Transport and Environment Committee

10.00 am Thursday, 31st March, 2022

DEPUTATION REQUESTS

Critical Concerns about the Design of Elm Row Public Realm

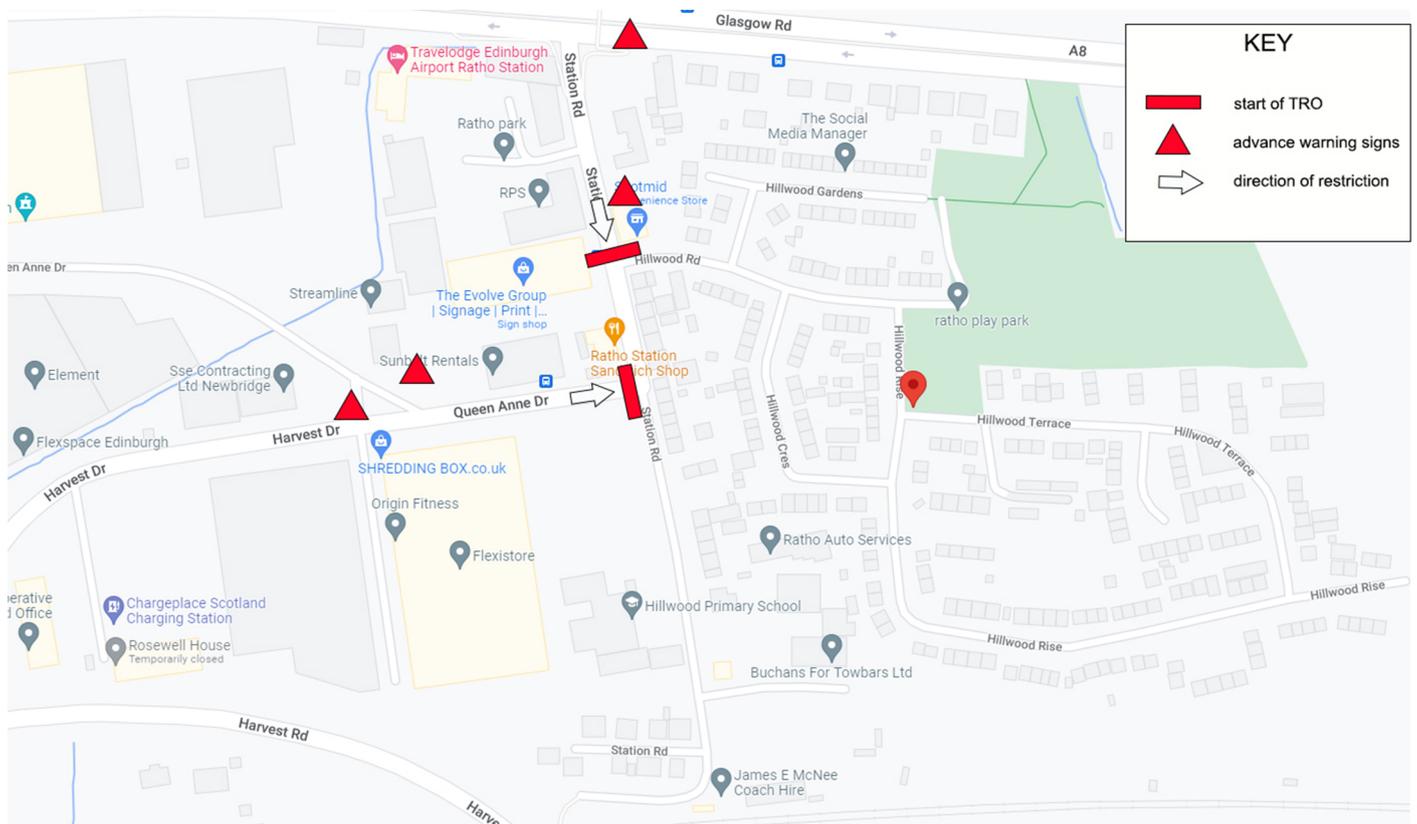
Below are some photographs showing the various problems. These are by no means all that there are, I have been sent dozens more by concerned residents:

A TRO restricting vehicles over a certain weight would limit the amount of these vehicles traversing Ratho Station significantly. We acknowledge there are some issues, which we address below:

Emergency / Council access - a condition of any TRO permitting 'authorised vehicles' would allow both emergency services as well as statutory Council services (such as bin collections) to operate as normal.

Public transport - As above, an exception allowing buses and coaches would permit First bus to operate as normal. There is a private coach operator in the village, at the top of Station Road, however we believe this exemption could be applied to them, in addition to any future public transport operators.

Delivery vehicles - We accept fully that there needs to be deliveries within the village, however it is our contention that the vast majority of these are already made in vans rather than LGV's, and so the only deliveries that would be impacted would be the Scotmid and the hotel. Whilst it would be preferable to have any restriction preventing LGV's turning left into Ratho Station from the A8, if any restriction were to start after immediately before the left turn into Hillwood Road that would allow service and delivery vehicles to access the hotel and store.
